**MINUTES  
BOARD OF ZONING APPEALS  
REVIEW MEETING  
LAKEWOOD CITY HALL  
AUDITORIUM  
MAY 18, 2023  
6:30 P.M.  
MEETING IS RECORDED  
<https://www.lakewoodoh.gov/videos-2/>**

# Board of Zoning Appeals

## May 18, 2023 Agenda

1464 Riverside

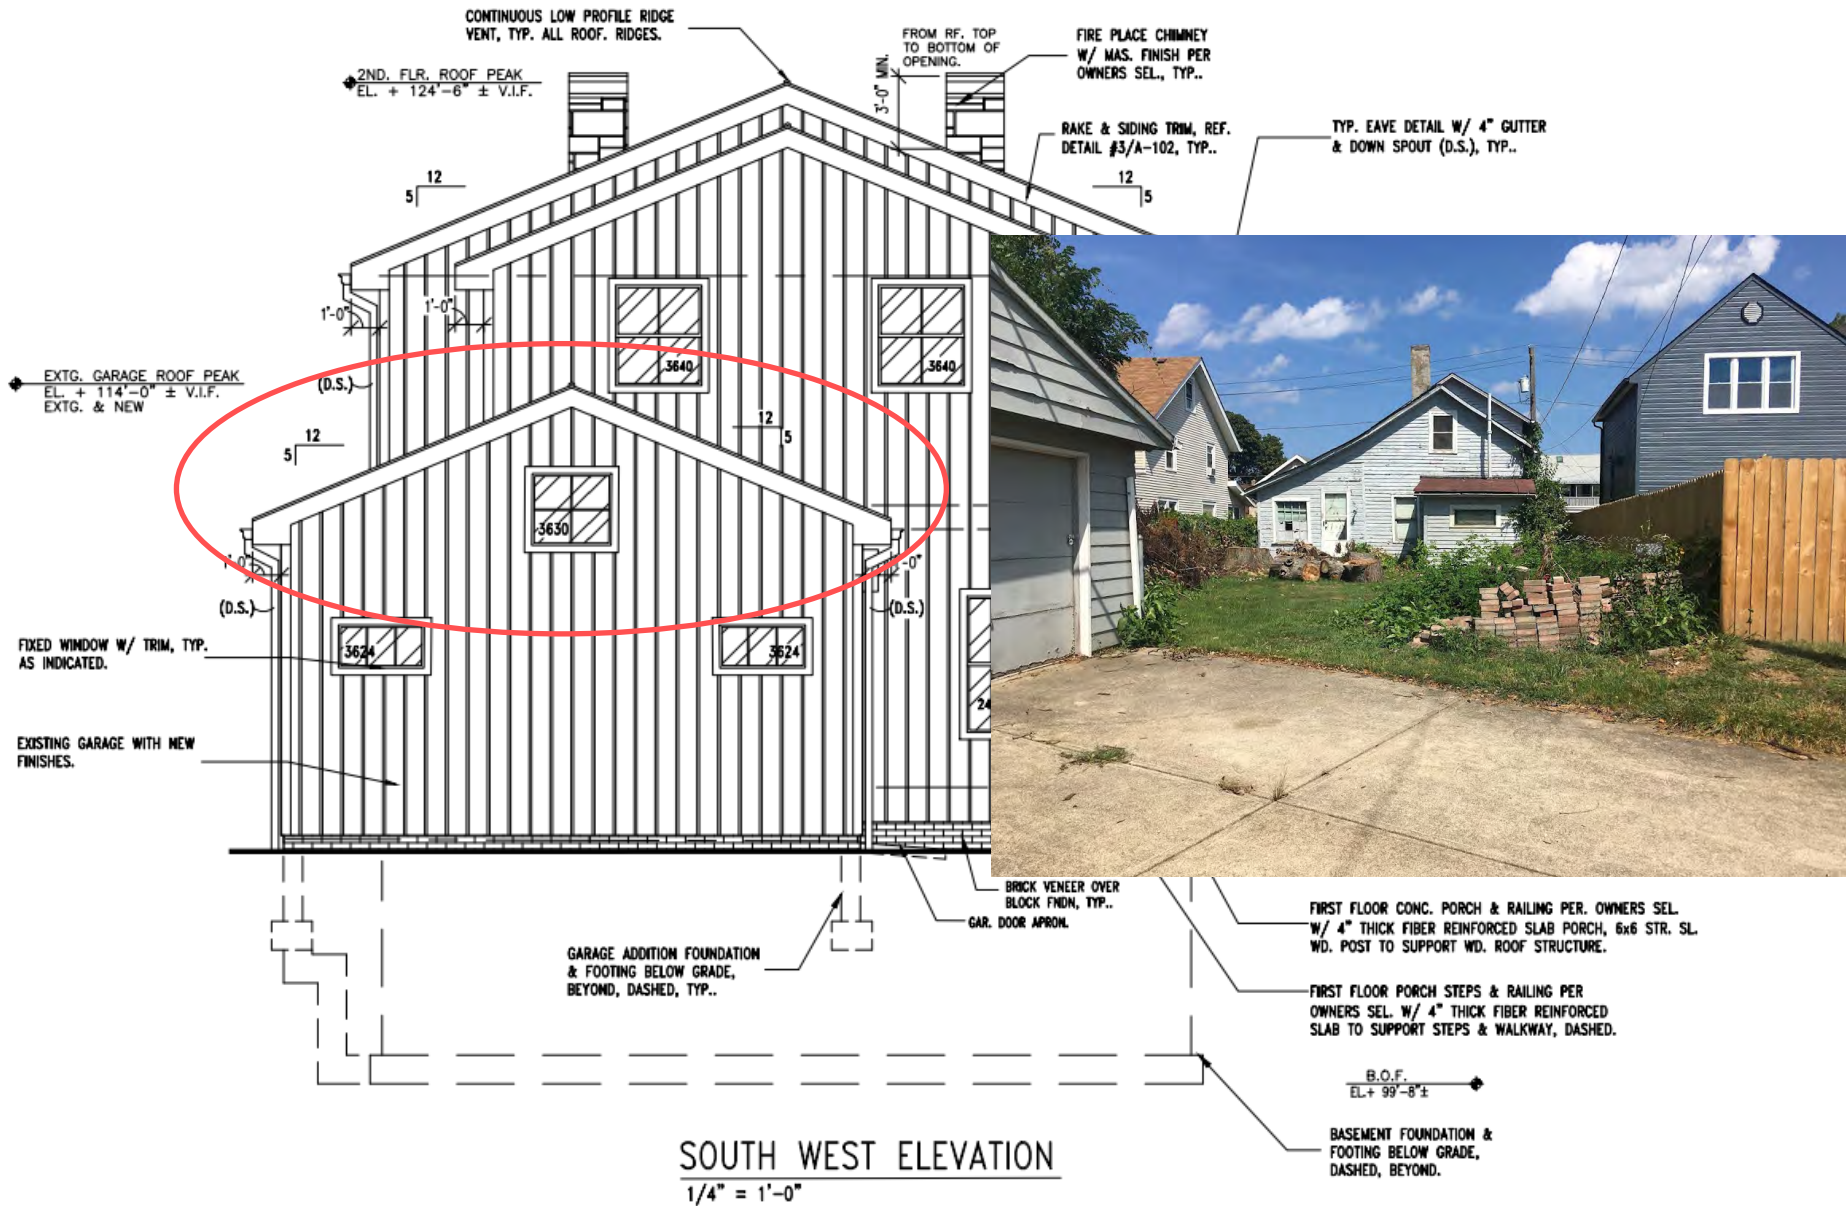
The proposed roof line is reversed from the existing

1464 Riverside Drive  
 (Alterations)  
 1464 Riverside Drive  
 Lakewood, Ohio

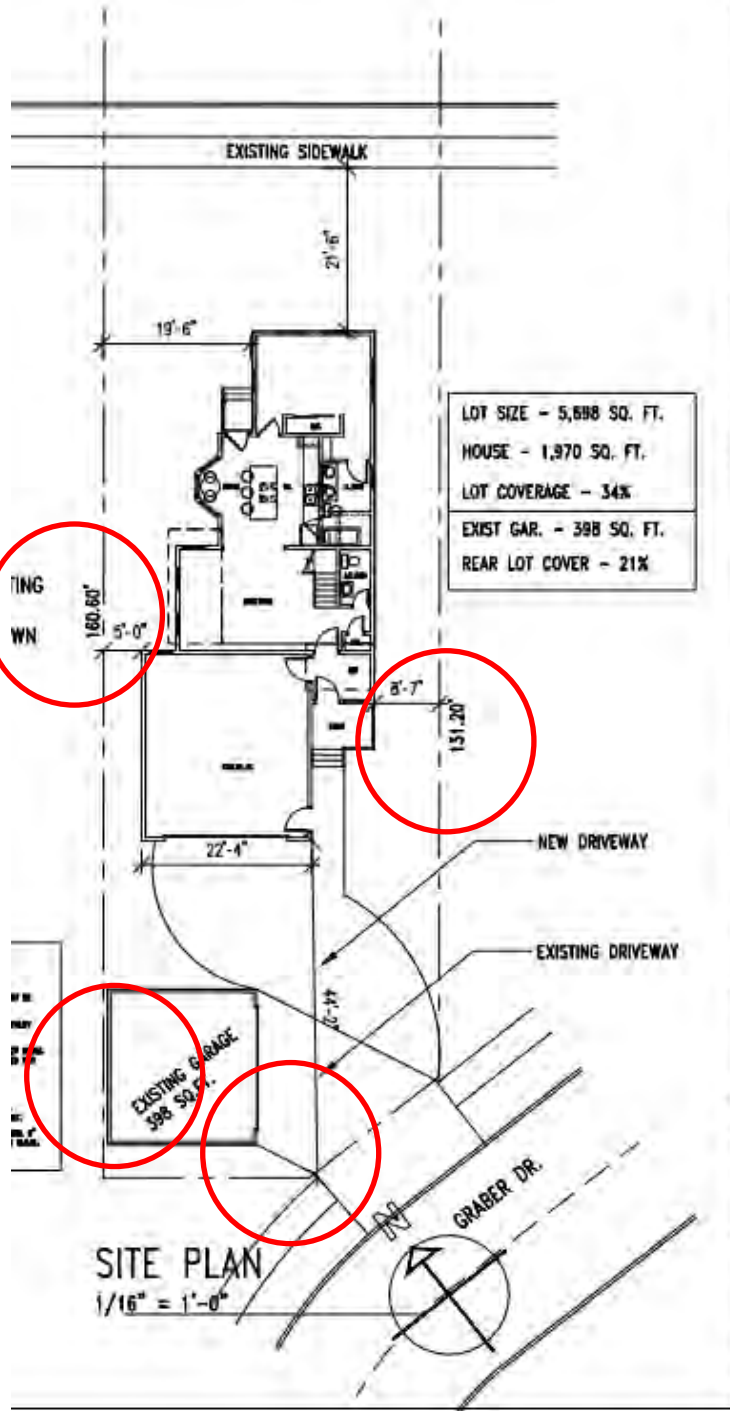
Given dimensions contradict

Given Dimensions contradict

- The submitted drawings do not match the setback on the mortgage survey, or the previously submitted drawings, or the county GIS that was submitted with the new site plan. There are 4 different sets of numbers

- **The administration recommends that the board defer the application and require the applicant to provide a boundary survey and a site plan that is based on the boundary survey. The boundary survey is necessary to eliminate the uncertainty created by the discrepancies in the applicant's provided documents.**

**MORTGAGE LOCATION SURVEY**

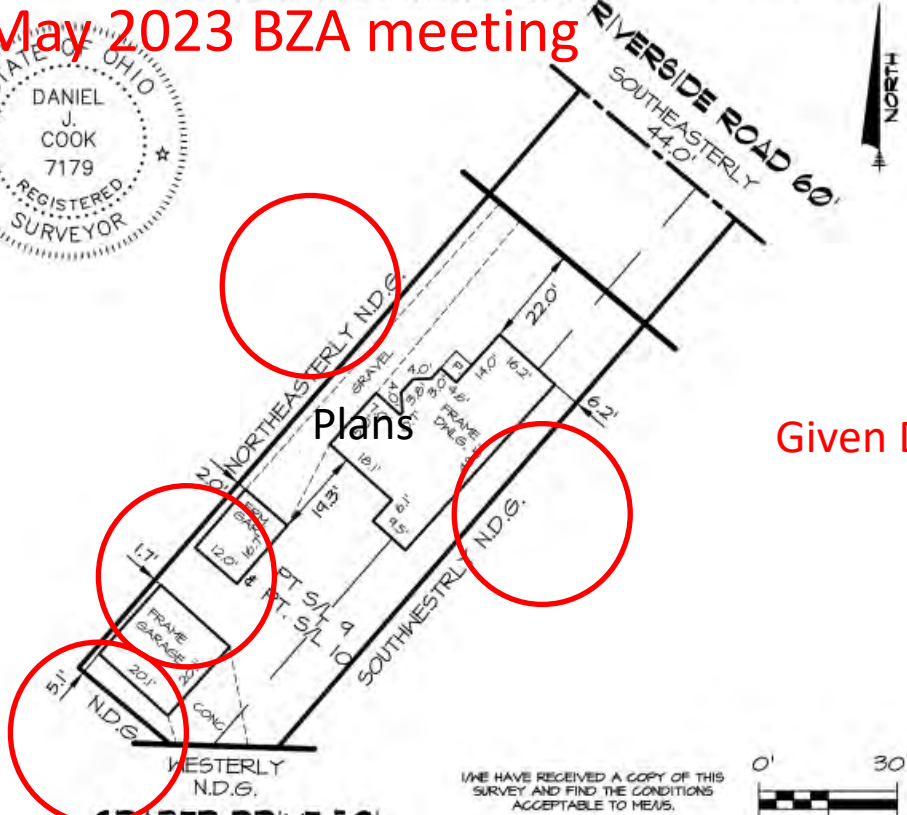
Given Dimensions contradict

- Distance of existing garage to public right of way
- A boundary survey by a registered surveyor is required by the building department for all new construction. The applicant has provided a mortgage location survey, which is not a boundary survey.
